WEST SUSSEX COUNTY COUNCIL CONSULTATION

TO:	Horsham District Council - FAO: Nicola Pettifer
FROM:	WSCC – Highways Authority
DATE:	29 April 2026
LOCATION:	Land South of Billingshurst Business Park (Phase 3) Hilland Road Billingshurst West Sussex
SUBJECT:	DC/26/0033 Outline permission for erection of buildings for Eg(iii)/B2/B8 use with associated yard areas, vehicle parking and access. All matters except access. More information received.
RECOMMENDATION:	More Information

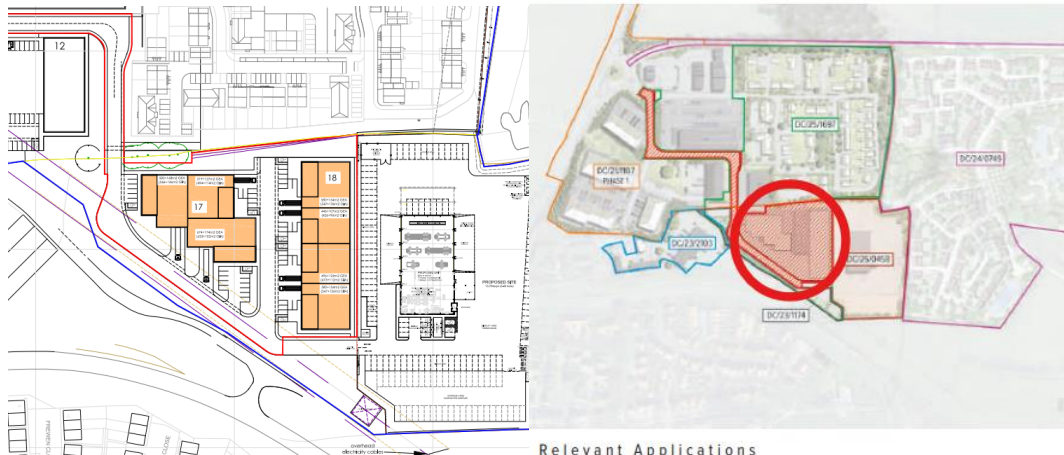
As it is stated the floor space is 4,885sqm of E(G)(iii)/B2/B8, some form of Travel Plan for staff would be expected. Whether this is a full Travel Plan or Travel Plan Statement would depend on use class/ floor area ratio. Applicant should clarify, noting the following:

4000sqm+ = full Travel Plan

B8 - 3000-5000sqm = Travel Plan Statement

2500sqm+ = full Travel Plan.
